Docket No. 272 – Development and Management Plan Inspection

Segment 4b Underground Line

Date: August 29, 2008

Location: Fairfield/Westport Town Line to Westport Avenue in Norwalk

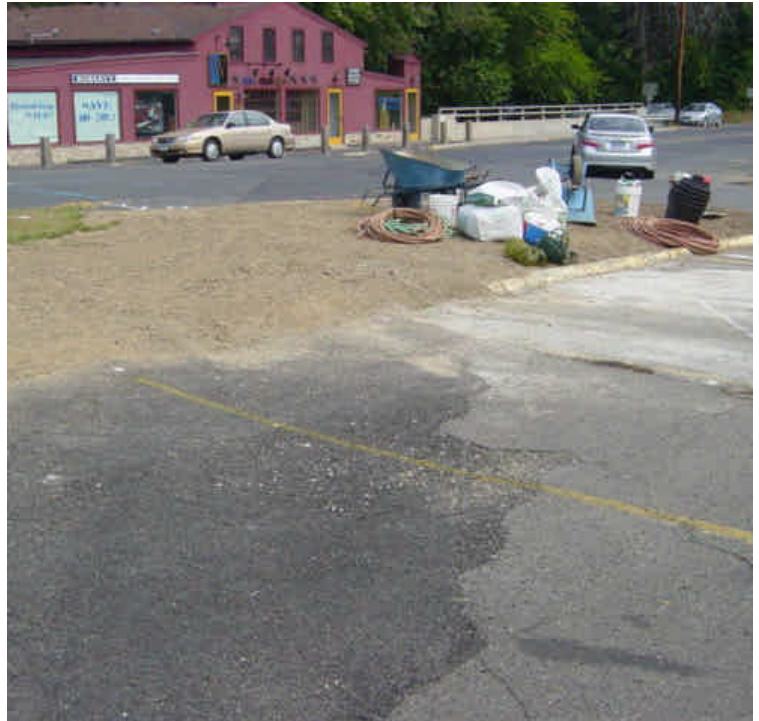
Topsoil has been spread in the area near sta. #130. Light poles and sidewalk have also been restored. Continue to stabilize with mulch and vegetation.

The area near vault #12 has been restored.

Topsoil remains over the area near sta. #316-318. The area has not yet been seeded or mulched and the bituminous curbing has not yet been replaced.

Restoration efforts were on going near sta. #433-434 and vault #26. Sweep adjacent roadways and parking areas as needed.
